IR Item	Response
1.1	
1. The 16m wide Esplanade Road is not consistent with PSP No 2 Engineering Standards Roads and Drainage Infrastructure;	<p>A modified local access typology has been proposed for the hilltop esplanade internal roads. The modification is for a reduction to the hillside verge width from 5.5m to 2.9m and an overall road reserve width from 19m to 16m. The verge reduction achieves a reduction in retaining wall heights to the hillside boundary and is appropriate due to this verge not including footpaths or services and not associated with allotment and/or driveway connections.</p> <p>Refer to RMA's Preliminary Engineering Assessment Report Revision 1 - Appendix B Drawing Numbers C-R0201 Issue B and C-R0203 Issue B in Attachment C for details of hierarchy location and the modified cross sections.</p>

Figure 1 – Length of pedestrian pathway before heading North or South (~247m)

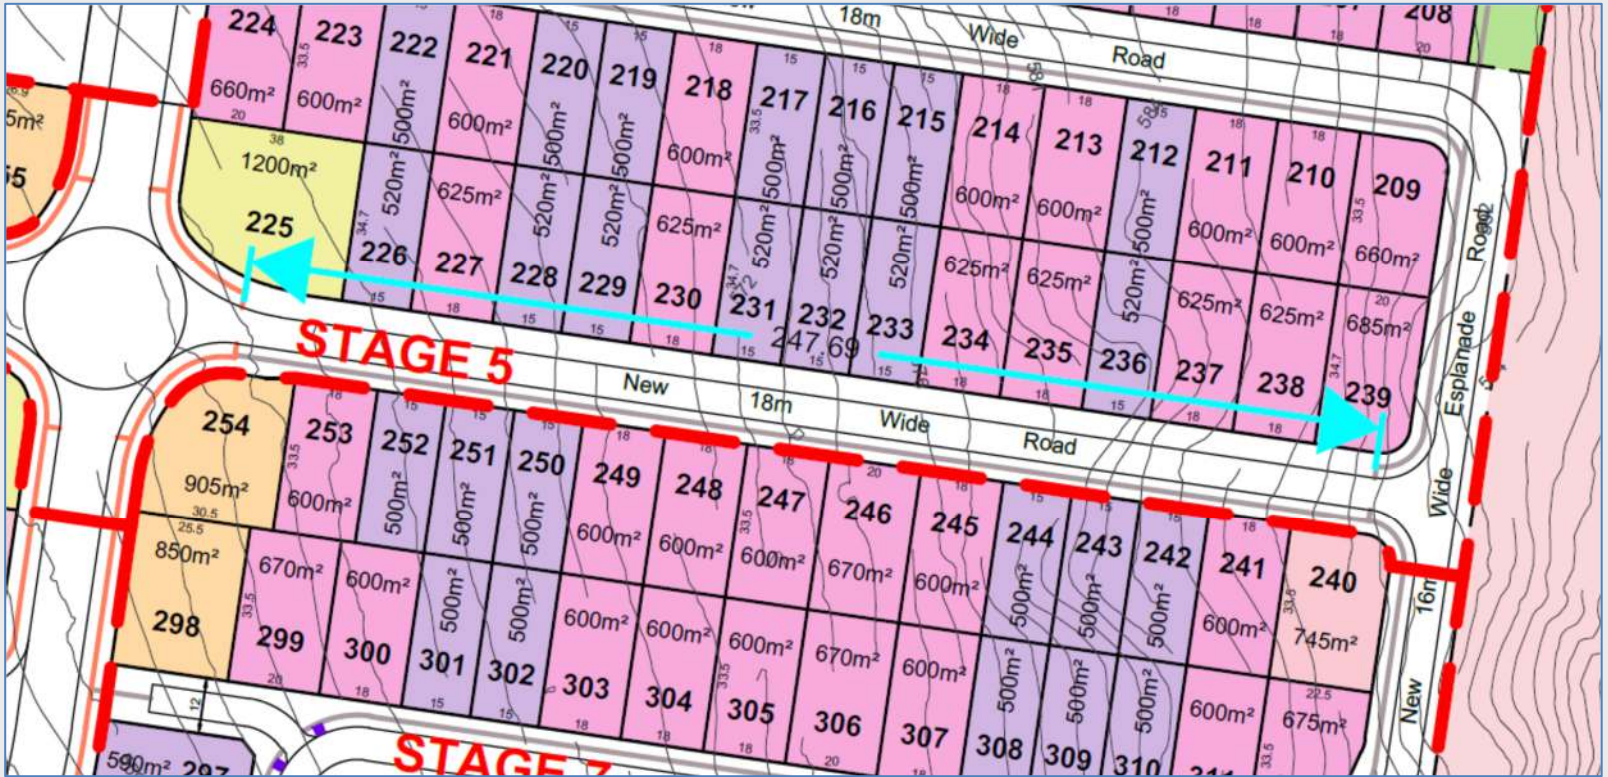
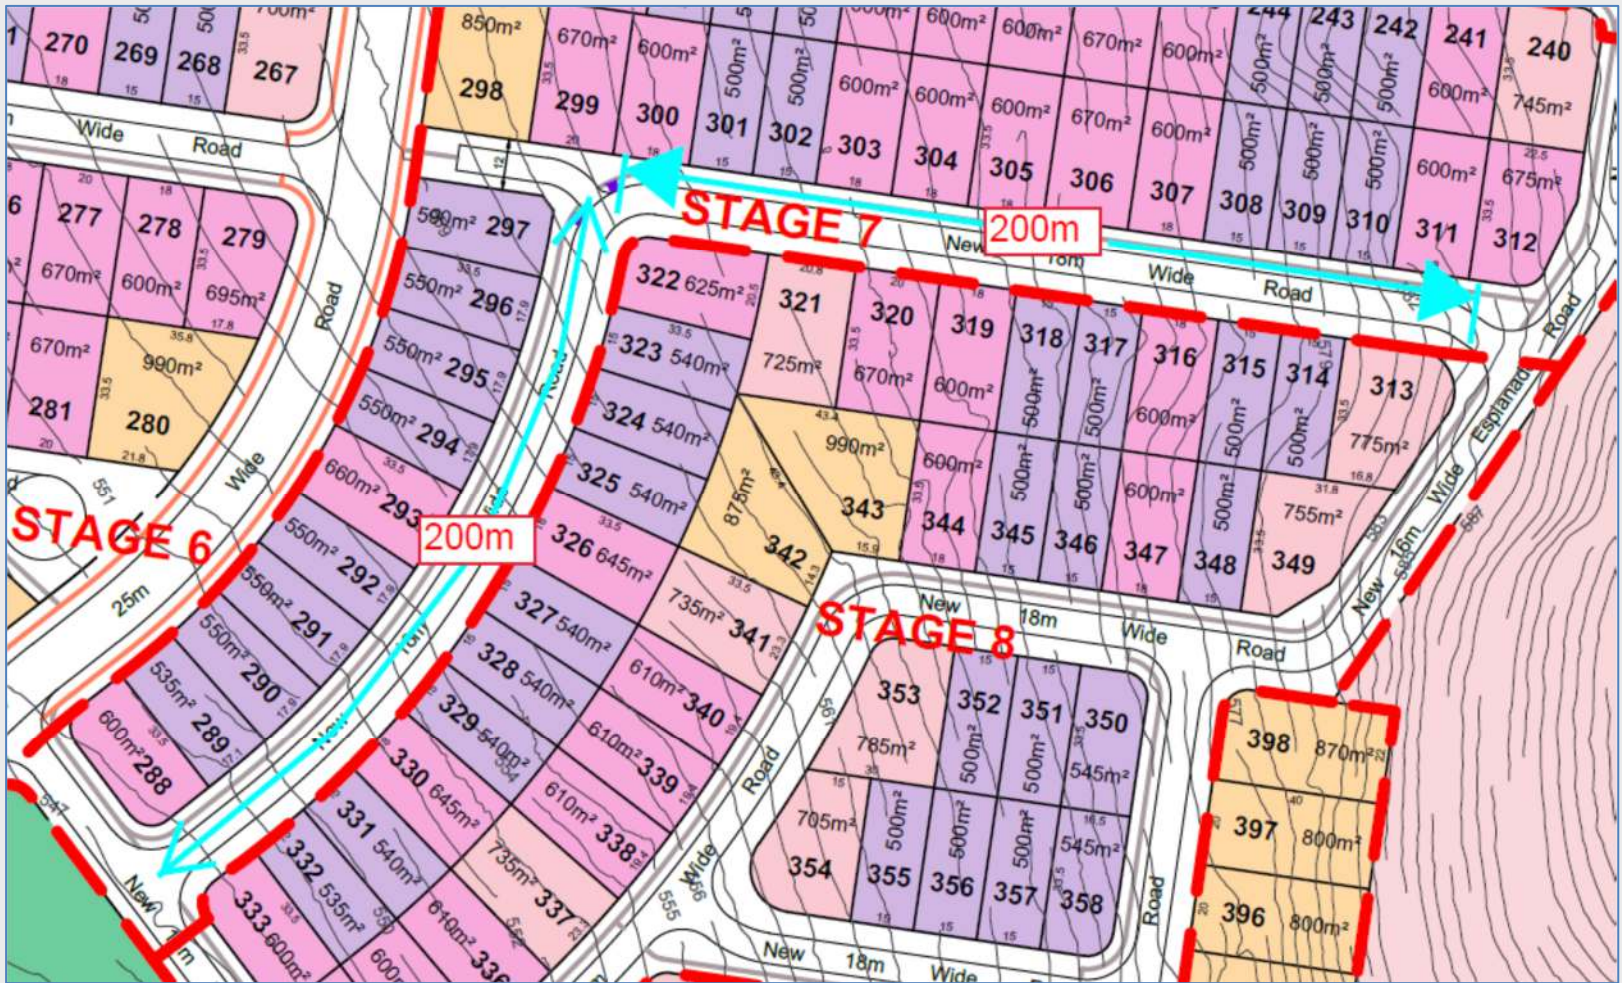
<p>11. There are numerous streets within the reconfiguration layout where the length between slow points (i.e.; intersections or curves) exceeds 120m, the worst example being the 18m Wide Road running parallel to Hursley Road through Stage 3 and 4 which is some 500m long. It is unclear how vehicle speeds will be controlled within streets having such a straight alignment.</p>	<p>Appropriate speed calming devices will be considered and detailed in relevant Operational Works submissions, and generally in accordance with the relevant TRC planning scheme policy requirements. This can be appropriately conditioned in the approval.</p>
<p>1.2 BLOCK LENGTH Please provide for an amended lot and road layout that provides for convenient pedestrian movement by reducing the length of street blocks identified above. The maximum length of each boundary of a block for the reconfiguration must not exceed 100 metres for street blocks fronting local streets, or 250m otherwise. This may require mid-block road connections or mid-block pedestrian links where appropriate.</p>	<p>We acknowledge that AO4.3 of the Reconfiguring a Lot Code specifies that street blocks fronting local streets do not exceed 100m in length. However, this is simply not a practical outcome and will result in very inefficient street/block pattern. The intent of this AO (as outlined in PO4) is to ensure that street blocks are arranged to provide an efficient neighbourhood pattern, that supports walking cycling and public transport use.</p> <p>In this instance, the 3 East/West blocks (i.e Lots 194-208, Lots 209-224, Lots 225-239, Lots 240-254, Lots 298-312) are largely constrained by the location of the Distributor Road to the West and the Hilltop Precinct to the East so it's difficult to reduce the length of these blocks without constructing a new road through them, which is considered unnecessary in this instance. While a series of cross-block links could be provided to split up these 3 blocks, these North/South linkages are unlikely to be utilised given the key desire lines for pedestrians on these blocks (i.e. the Distributor Road/future bus routes and the Hilltop Precinct/future park) are all located East/West so pedestrians will have little need to access these North/South pedestrian corridors. We note that PO5 of the 'Model Code for Neighbourhood Design' only suggests the provision of a mid-block path for pedestrian and cyclist movement where this improves connectivity to open space and recreation facilities, community facilities, centres and places of employment – which is not the case in this instance. The cross-block links would also be ~67m long which is not best CPTED practices.</p> <p>In this instance, the East/West block lengths are only marginally greater than 250m (which is the typical maximum block length considered to achieve good pedestrian connections). Furthermore, while the block length may be greater than 250m when measured from centreline to centreline, in reality, pedestrians that are walking East/West along these blocks will not travel more than 250m along the proposed footpath before heading North or South along the shorter block (refer to Figure 1 below).</p> <p>In relation to the block featuring Lots 313 – 349, we note that this is not a typical grid pattern block in that it is specifically designed to suit the contours of the area. In this instance, the block essentially consists of 2 separate streets - an East-West section which runs for ~200m and then a North-South section which runs for approximately ~200m (refer to Figure 2 below), which supports a high degree of pedestrian connectivity to all directions.</p> <p>Overall, the proposed development is considered to create a walkable residential neighbourhood and the movement system provides for high levels of permeability and safety for all users and facilitates high levels of accessibility by walking and cycling.</p>

Figure 3 – Indicative bin collection pad locations

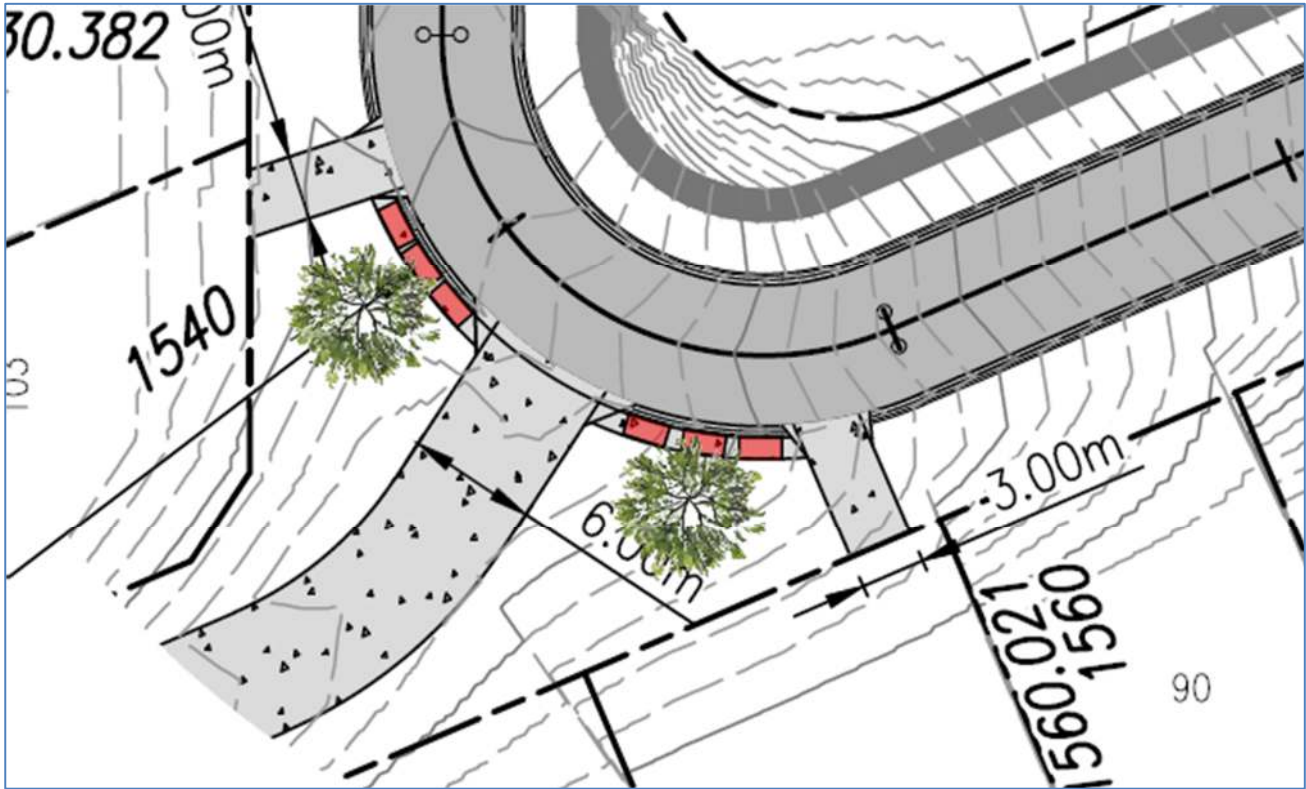
Please provide for an amended lot and road layout that allows safe movement of waste collection vehicles and service of wheelie bins from the kerbside in front of each allotment. Presenting bins in front of other properties is to be eliminated. Roads are to be designed to eliminate the need for a waste collection vehicle to reverse to enter a road and service bins from a kerbside.

The potential to amend the proposed road layout and remove shared driveways was investigated. However, the topographical constraints and more specifically, the street drainage network performance (including major stormwater freeboard requirements) restricted the opportunity for redesign. Therefore, the street layout and laneways has been retained as initially submitted. Bin collection for laneway lots will occur from the adjacent street kerbing through appropriately designed and constructed bin collection pads and appropriately located and constructed laneway and driveways. Refer to the RMA Preliminary Engineering Assessment Report Revision 1 - Appendix B, Drawing Numbers C-R0311 Issue B in **Attachment C** for indicative bin collection pad details.

We believe that this solution is an appropriate solution given the circumstances, as there is sufficient space within the verge to accommodate bin collection pads while maintaining access to all lots and still providing for landscaping trees within the verge (refer to **Figure 3** below). It is noted that a similar outcome has been approved by Council on a number of other developments (refer to example in **Figure 4** below). We request Council to condition bin pads to be provided kerbside for associated laneway lots, to be assessed and approved at the relevant operational works stages.

Figure 5 – Proposed Cul-de-Sac Typical Cross Section

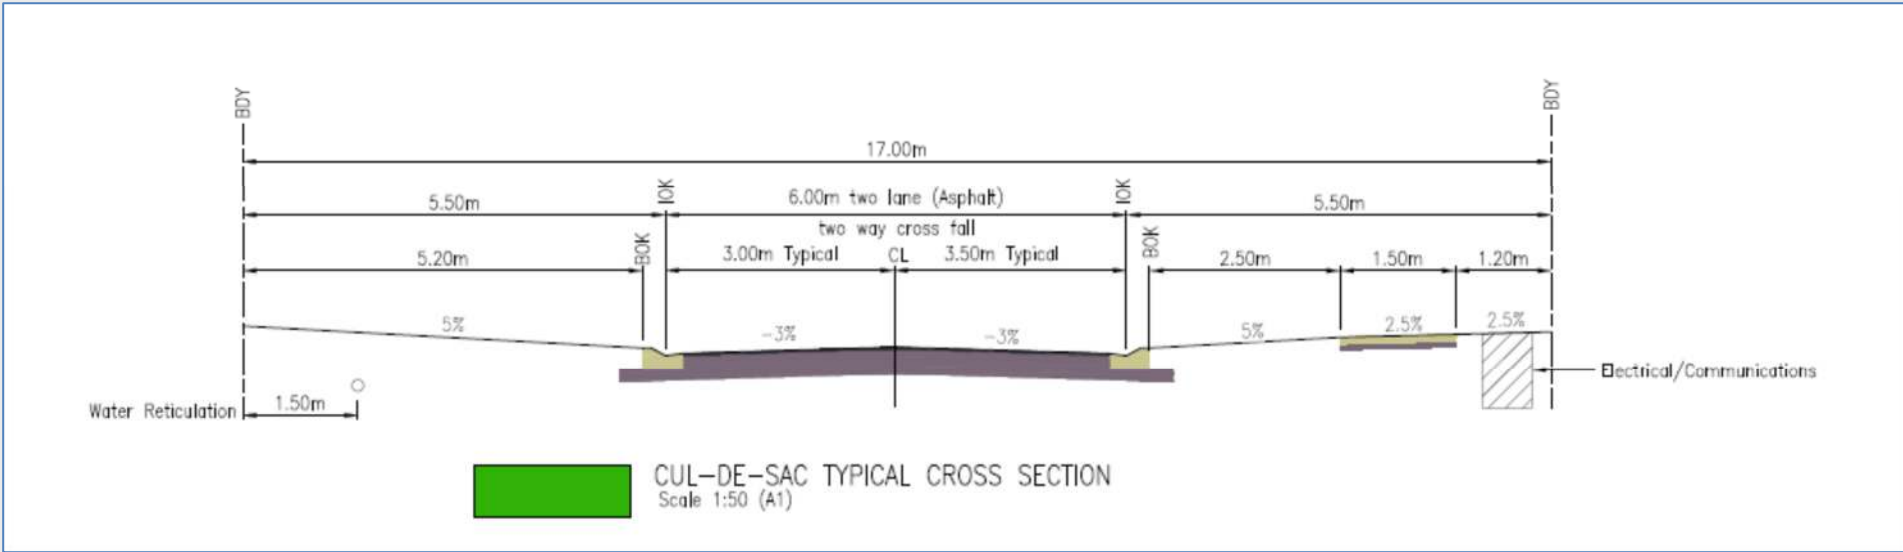
7.1 Please submit an amended plan of subdivision and engineering documents that provides planting areas above and below ground for the provision of street trees in accordance with PSP No. 2 – Engineering Standards – Roads and Drainage Infrastructure SC.6.2.2.3.12 Tree Planting for the ‘Local Access Esplanade’ road and ‘Cul-de-sac’ road.

The Preliminary Engineering Assessment Report has been amended to clarify that a 17m wide cross-section will be provided for all cul-de-sac roads in accordance with Council’s standard drawings (refer to **Figure 5** below and the cross sections in the Preliminary Engineering Assessment Report in **Attachment C**).
